## **Exhibit 2: Gershwin Theater**

### **Exhibit 2B: Architectural Modifications**

**Exh. 2B Architectural Modifications to Gershwin Theater**

### **Exhibit 2C: Seating**

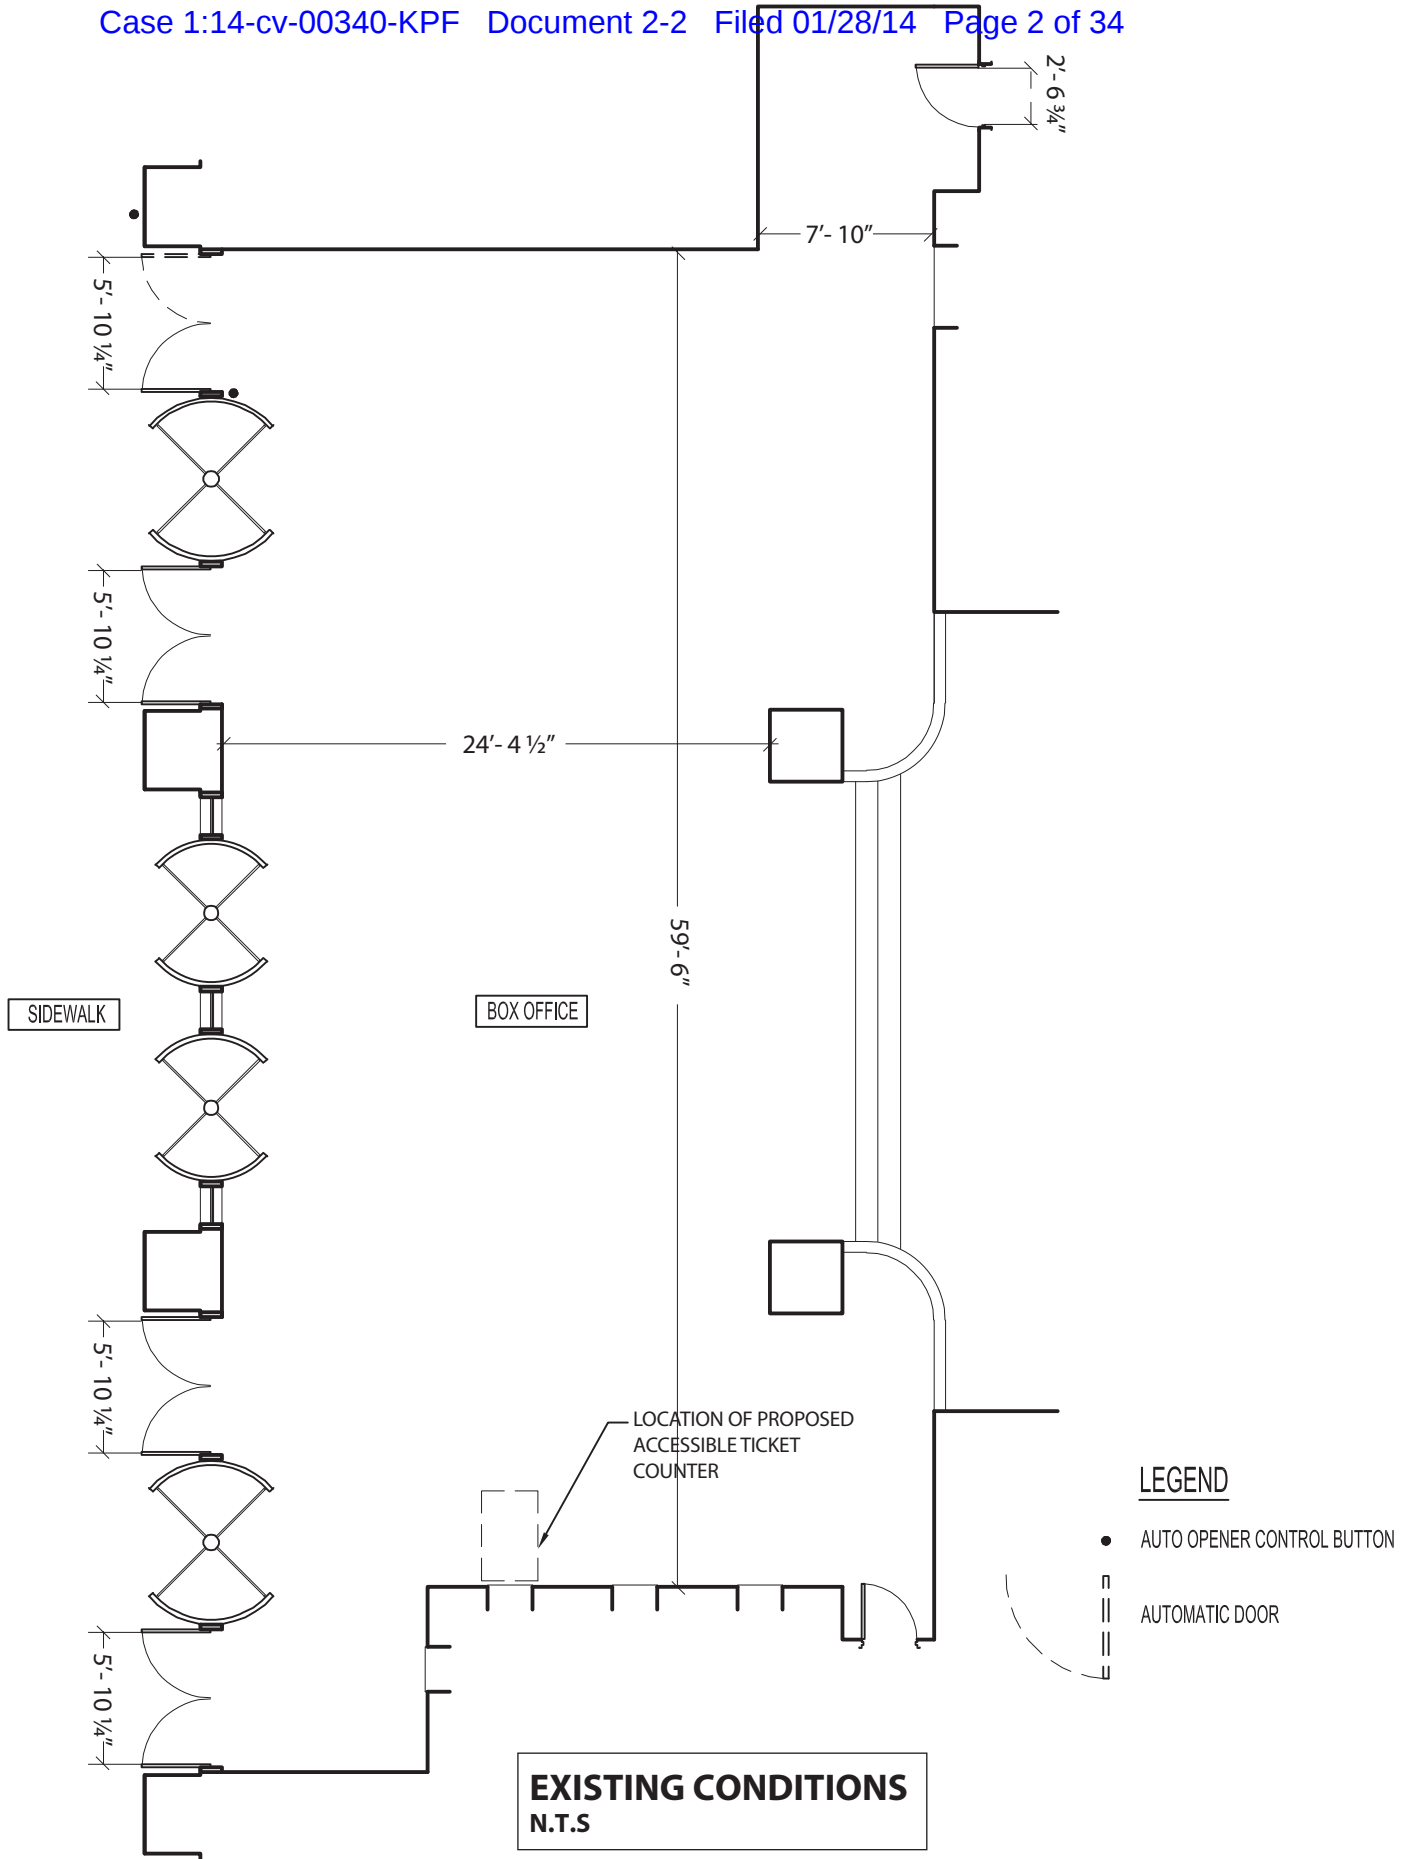
1. Nederlander shall maintain the four existing wheelchair and companion seating locations on the Orchestra level at ZZ13, ZZ15, ZZ14, and ZZ16, with ZZ11, ZZ17, ZZ12, and ZZ18 being companion seating locations.
2. Nederlander shall add four wheelchair seating locations, at Orchestra ZZ1/ZZ3, and ZZ2/ZZ4, and at Front Mezzanine at D31 and D32, with Orchestra ZZ5 and ZZ6, and Front Mezzanine D29 and D30 being companion seating locations.

3. Nederlander shall add eighteen aisle transfer seating locations at Orchestra BB1, BB118, A101, A2, E118, K101, N1, N35, N2, N36, Q35, Q36, and at Front Mezzanine D2, C118, E101, and E116, and at Rear Mezzanine J33, and J34.

**2. GERSHWIN THEATER  
NORTH ROTUNDA - MEN'S TOILET ROOM PLAN**

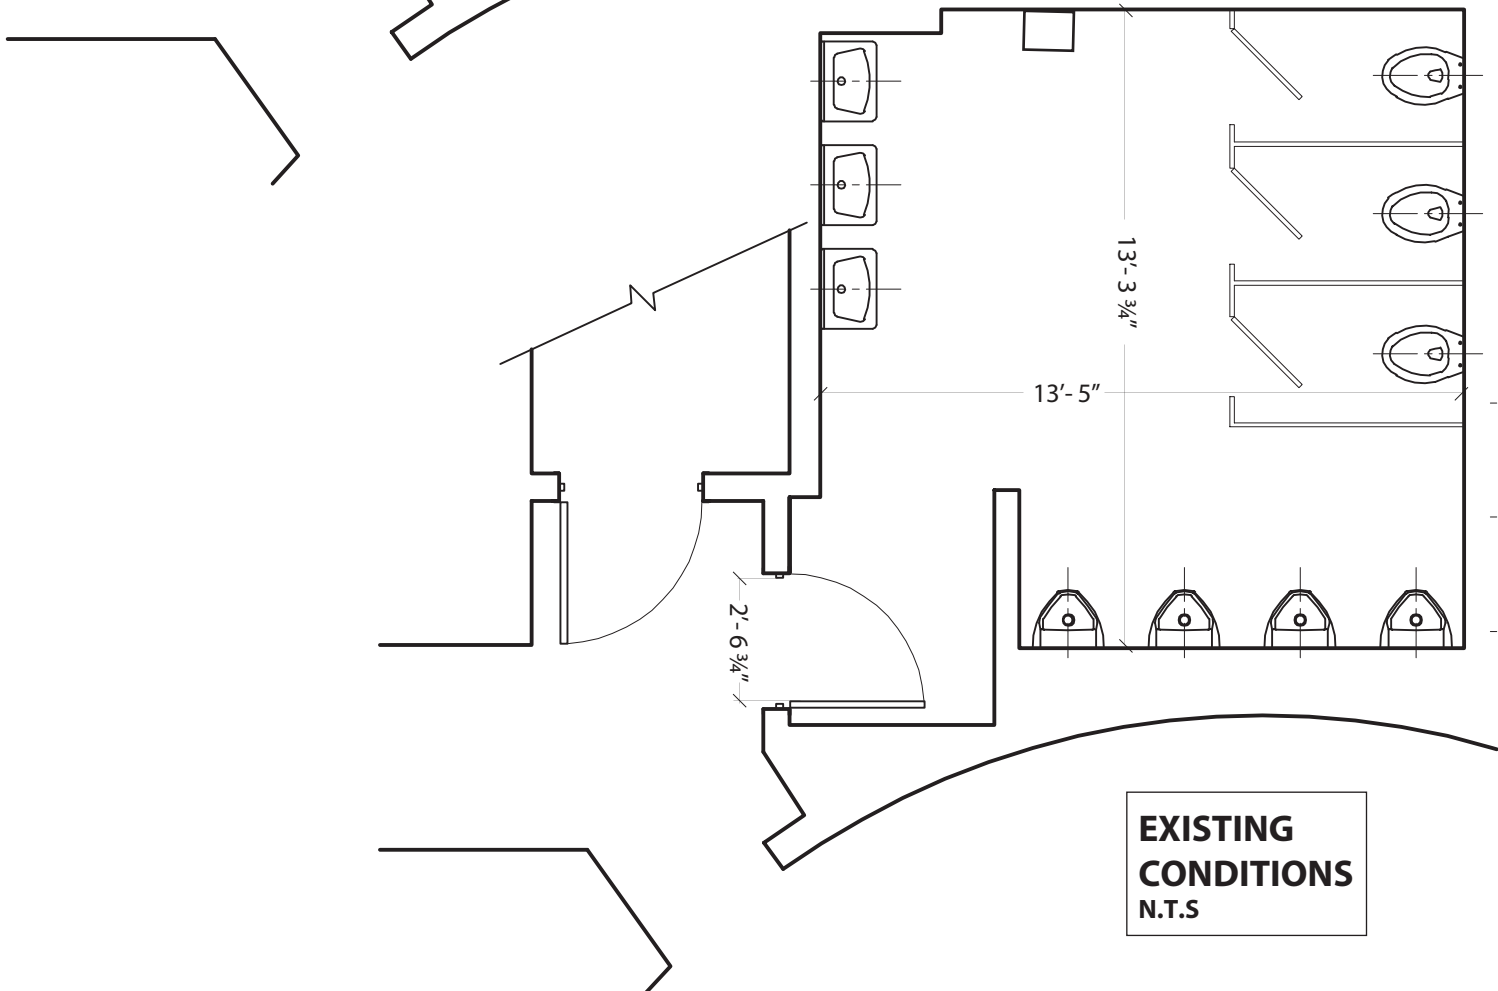
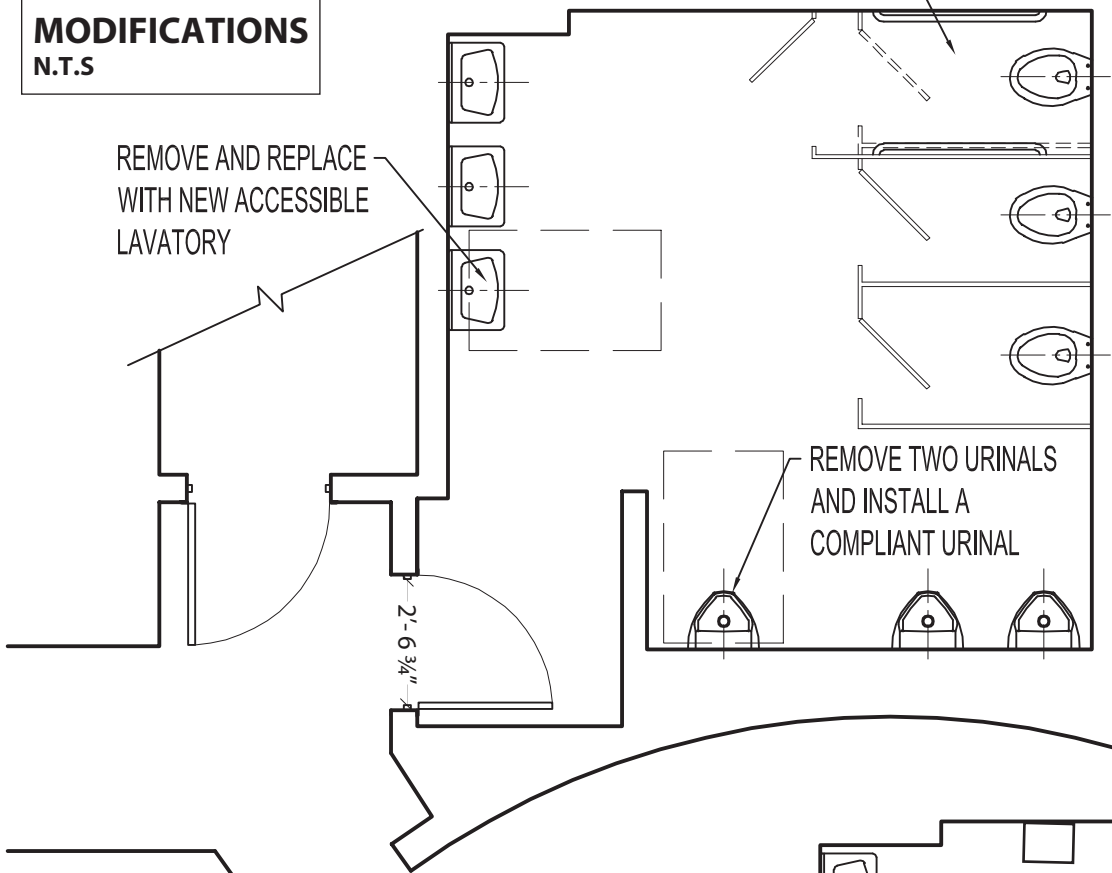
REMOVE PARTITION AS REQUIRED AND  
INSTALL NEW AMBULATORY STALL

REMOVE AND REPLACE  
WITH NEW ACCESSIBLE  
LAVATORY

REMOVE TWO URINALS  
AND INSTALL A  
COMPLIANT URINAL

2. **GERSHWIN THEATER**  
**4TH FLOOR SOUTH - WOMEN MULTI-USER TOILET ROOM PLAN**

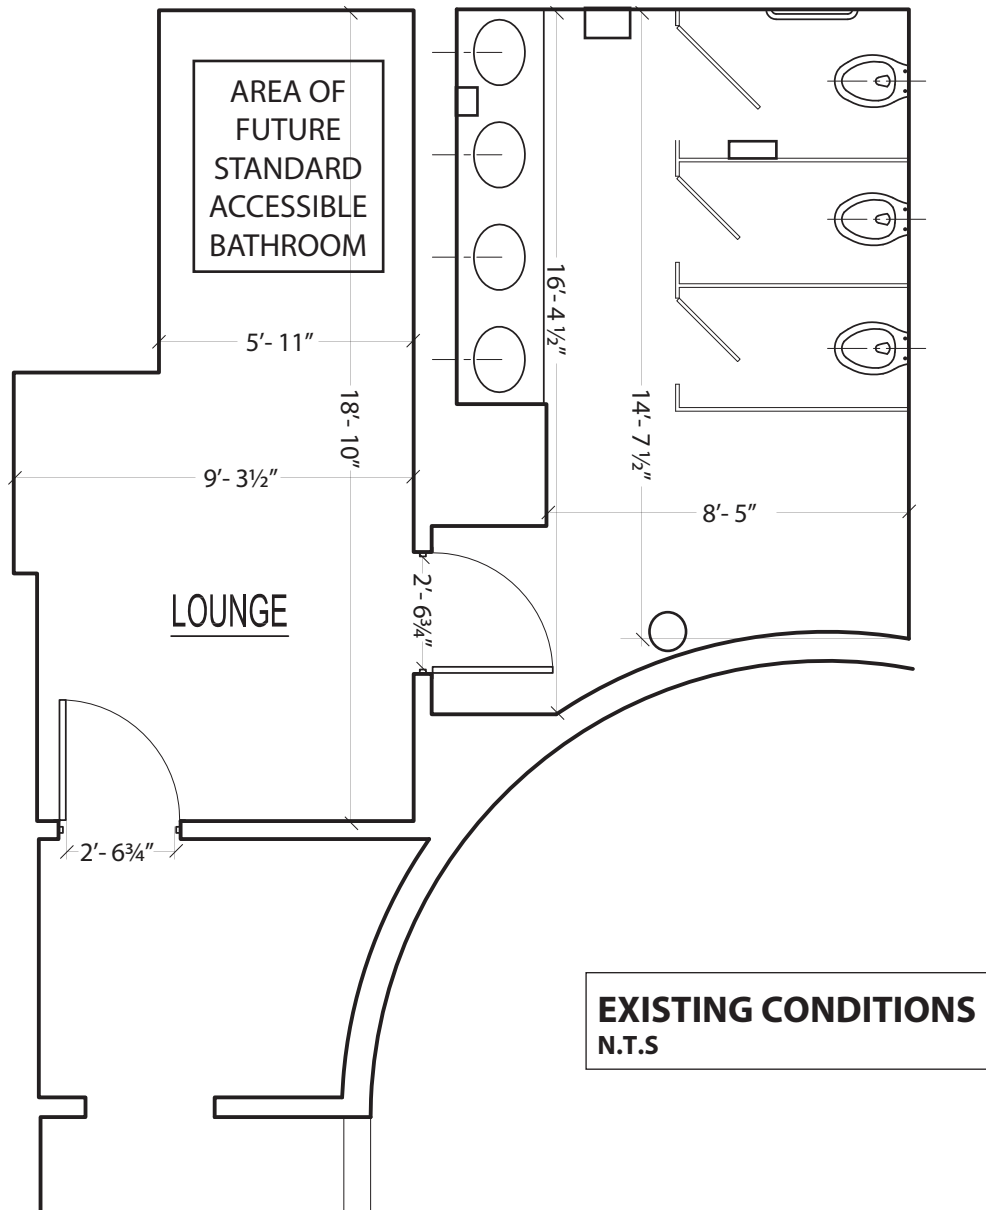
23	Fourth Level (Women's Multi-user Toilet Room, South)	The main entry door is 34" wide and provides 31" clear width.	Remove existing door, widen opening, and install new door that provides the minimum required clear width. Coordinate with maneuvering clearance requirements.	4.1.3(7)(c) 4.13.5 Fig. 24 4.13.9 4.13.10	<b>Defendant will provide a compliant door.</b>
24	Fourth Level (Women's Multi-user Toilet Room, South)	The door from the lounge to the toilet room is 34" wide and provides 31" clear width.	Remove existing door, widen opening, and install new door that provides the minimum required clear width. Coordinate with maneuvering clearance requirements.	4.1.3(7)(c) 4.13.5 Fig. 24 4.13.9 4.13.10 4.13.11	<b>Defendant will provide a compliant women's standard accessible bathroom on fourth level South adjacent to lounge entrance to women's room on fourth level South.</b>
25	Fourth Level (Women's Multi-user Toilet Room, South)	Door hardware requires tight grasping, pinching, and/or twisting of the wrist to operate.	Remove existing operating hardware and install compliant hardware.	4.1.3(7)(c) 4.13.9	<b>Defendant will provide a compliant women's standard accessible bathroom on fourth level South adjacent to lounge entrance to women's room on fourth level South.</b>

<b>Line #</b>	<b>Location Description</b>	<b>Existing Condition</b>	<b>Barrier Description</b>	<b>1991 Standards Reference</b>	<b>Architectural Modification</b>
26	Fourth Level (Women's Multi-user Toilet Room, South)	Door hardware requires tight grasping, pinching, accessible, the doors below the call buttons are inaccessible.	Remove existing operating hardware and install compliant hardware.	4.1.3(7)(c) 4.13.9	Defendant will provide a compliant women's standard accessible bathroom on fourth level South adjacent to lounge entrance to women's room on fourth level South.
27	Fourth Level (Women's Multi-user Toilet Room, South)	The pull side maneuvering clearance width is 8.5".	Alter existing walls and/or relocate existing door and frame to obtain required maneuvering clearances.	4.13.6 Fig. 25(a-f)	Defendant will provide a compliant women's standard accessible bathroom on fourth level South adjacent to lounge entrance to women's room on fourth level South.

28	Fourth Level (Women's Multi-user Toilet Room, South)	The wall sconce protrudes into the circulation path 9" at 53" AFF.	Raise wall sconce to greater than 80" AFF without altering fixture.	4.4.1 Fig. 8 (a-e)	Defendant will provide a compliant women's standard accessible bathroom on fourth level South adjacent to lounge entrance to women's room on fourth level South.
29	Fourth Level (Women's Multi-user Toilet Room, South)	The side grab bar is 28.25" AFF, mounted 17" from the rear wall, and is 24" long.	Remove existing side grab bar and install new compliant side grab bar. Ensure that grab bar is mounted 12" maximum from rear wall and extends at least 54" from rear wall (or 52" if in stall).	4.1.3(11) 4.22.4 4.17.6 4.26 Fig.30	Defendant will provide a compliant women's standard accessible bathroom on fourth level South adjacent to lounge entrance to women's room on fourth level South.
30	Fourth Level (Women's Multi-user Toilet Room, South)	Knee space at the counter mounted lavatories is 26.25" AFF.	Remove the existing lavatory and counter. Install a new compliant counter and reinstall the existing lavatory. Repair/refinish wall as needed.	4.1.3(11) 4.22.6 4.19.2 Fig. 31	Defendant will provide a compliant women's standard accessible bathroom on fourth level South adjacent to lounge entrance to women's room on fourth level South.

<b>Line #</b>	<b>Location Description</b>	<b>Existing Condition</b>	<b>Barrier Description</b>	<b>1991 Standards Reference</b>	<b>Architectural Modification</b>
31	Fourth Level (Women's Multi-user Toilet Room, South)	This non-fire rated door requires 10 pounds of force to open and travels from 70° open to within 3" of the latch in 2.22 seconds.	Adjust the existing closer to provide compliant speed and force. (May inhibit proper latching. If so, replace existing closer with compliant model which allows door to operate as intended).	4.1.3(7)(c) 4.13.10	<b>Defendant will provide a compliant women's standard accessible bathroom on fourth level South adjacent to lounge entrance to women's room on fourth level South.</b>
32	Fourth Level (Women's Multi-user Toilet Room, South)	This non-fire rated door requires 10 pounds of force to open and travels from 70° open to within 3" of the latch in 2.5 seconds.	Adjust the existing closer to provide compliant speed and force.	4.1.3(7)(c) 4.13.10	<b>Defendant will provide a compliant closer and latch.</b>

33	Fourth Level (Women's Multi-user Toilet Room, South)	The soap dispenser is mounted at 54" AFF, 15" deep, side reach.	Relocate the existing soap dispenser within reach range.	4.1.3(11) 4.22.7 4.27 4.2.5 4.2.6	<b>Defendant will provide a compliant women's standard accessible bathroom on fourth level South adjacent to lounge entrance to women's room on fourth level South.</b>
34	Fourth Level (Women's Multi-user Toilet Room, South)	The threshold at the door from the lounge to the toilet room has a 1/2" vertical rise and is unbeveled on the toilet room side of the threshold.	Remove the existing threshold and install a compliant threshold.	4.1.3(7)(c) 4.1.6(3)(d)(ii) 4.13.8 4.5.2 Fig. 7(c,d)	<b>Defendant will provide a compliant women's standard accessible bathroom on fourth level South adjacent to lounge entrance to women's room on fourth level South.</b>
35	Fourth Level (Women's Multi-user Toilet Room, South)	The toilet paper dispenser is mounted 39.75" from the rear wall on the side opposite the side grab bar.	Relocate existing compliant toilet paper dispenser as required, ensuring 1 1/1" clearance below grab bar. Repair/refinish wall or partition as needed.	4.16.6 Fig. 29(b), Fig. 30(d)	<b>Defendant will provide a compliant women's standard accessible bathroom on fourth level South adjacent to lounge entrance to women's room on fourth level South.</b>

<b>Line #</b>	<b>Location Description</b>	<b>Existing Condition</b>	<b>Barrier Description</b>	<b>1991 Standards Reference</b>	<b>Architectural Modification</b>
36	Fourth Level (Women's Multi-user Toilet Room, South)	There are 3 stalls in this toilet room, the largest being 44" wide x 53" deep with an inswinging door.	Creation of a compliant standard accessible stall requires removal of existing fixture(s). Relocate partition(s) and fixture(s) as required.	4.1.3(11) 4.22	Defendant will provide a compliant women's standard accessible bathroom on fourth level South adjacent to lounge entrance to women's room on fourth level South.
37	Fourth Level (Women's Multi-user Toilet Room, South)	There is no raised lettering and Braille room identification sign provided at this gender specific multi-user toilet room.	Install compliant (includes raised lettering and Braille) room identification signage adjacent to strike side of door at 60" AFF to centerline. Coordinate with requirement for close approach without encountering protruding object or door swing.	4.1.3(16)(a) 4.30.1 4.30.4 4.30.5 4.30.6	Defendant will provide compliant sign.

38	Fourth Level (Women's Multi-user Toilet Room, South)	There is no rear grab bar.	Install new compliant rear grab bar. Provide backing in wall as necessary.	4.17.6 Fig. 29, Fig.30	Defendant will provide a compliant women's standard accessible bathroom on fourth level South adjacent to lounge entrance to women's room on fourth level South.
39	Fourth Level (Women's Multi-user Toilet Room, South)	The water closet seat height is 15" AFF and it is mounted 21.5" to centerline from the side wall.	Floor-mounted water closet: replace existing water closet with compliant water closet with seat installed 17"-19" AFF and 18" centerline to side wall. Adapt flush control as needed.	4.16.3 Fig. 29(b) 4.16.2 4.17.3 Fig. 28, Fig. 30	Defendant will provide a compliant women's standard accessible bathroom on fourth level South adjacent to lounge entrance to women's room on fourth level South.
40	Fourth Level (Women's Multi-user Toilet Room, South)	The paper towel dispenser is mounted at 58" AFF.	Install new towel dispenser within reach range where required clear floor space is available. Existing noncompliant towel dispenser may remain.	4.1.3(11) 4.22.7 4.27.3	Defendant will provide a compliant women's standard accessible bathroom on fourth level South adjacent to lounge entrance to women's room on fourth level South.
